Access Compliance Report

Public Rights-of-Way

(Curb Ramps)

Intersection ID: 32316	Main Street: NEW_PROVIDENCE_LN	Cross Street: WOODCLIFF_CT	Location: W
ADA ID: 4F8B4EFA19C1	Ramp Type: PerpDiag	Initial Pass/Fail: Fail	Overall Compliance: No
			Severity Score: 46.25

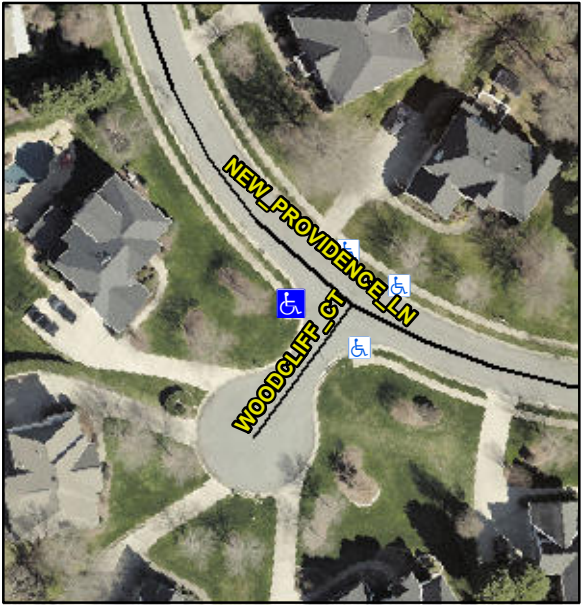
Codes/Mitigation Info/Possible Solution			Field Measurements/Component Compliance		
	Possible Solutions:		Compliance	Description	Data
	Remove & Replace Curb Ramp With Two New Directional Ramps or Equivalent.		No	Ramp Length (in)	52.0
			No	Ramp Width (in)	43.0
			N/A	Flare Type LT	N/A
			N/A	Flare Slope LT (%)	N/A
			N/A	Flare Traversable LT?	N/A
			N/A	Landing Length (in)	N/A
			N/A	Landing Width (in)	N/A
			N/A	Landing Slope (%)	N/A
			N/A	Landing X Slope (%)	N/A
			N/A	Landing Curb? (Y/N)	N/A
			N/A	Shared Landing?	N/A
			N/A	Gutter Ponding?	N/A
			N/A	Gutter Lip Ht (in)	2.5
			N/A	Painted X Walk1?	No
				X Walk 1 Direction	To SE
			N/A	X Walk 1 Width (in)	N/A
				X Walk 1 Slope (%)	3.6
				X Walk 1 X Slope (%)	4.7
			N/A	Ramp inside XWalk1?	N/A
<p>Surveyor Notes:</p> <p>N/A</p> <p>PROW/ADA:</p> <p>R304.5.1, R304.2.2, R304.5.3</p>			N/A	Flare Type RT	N/A
			N/A	Flare Slope RT (%)	N/A
			N/A	Flare Traversable RT?	N/A
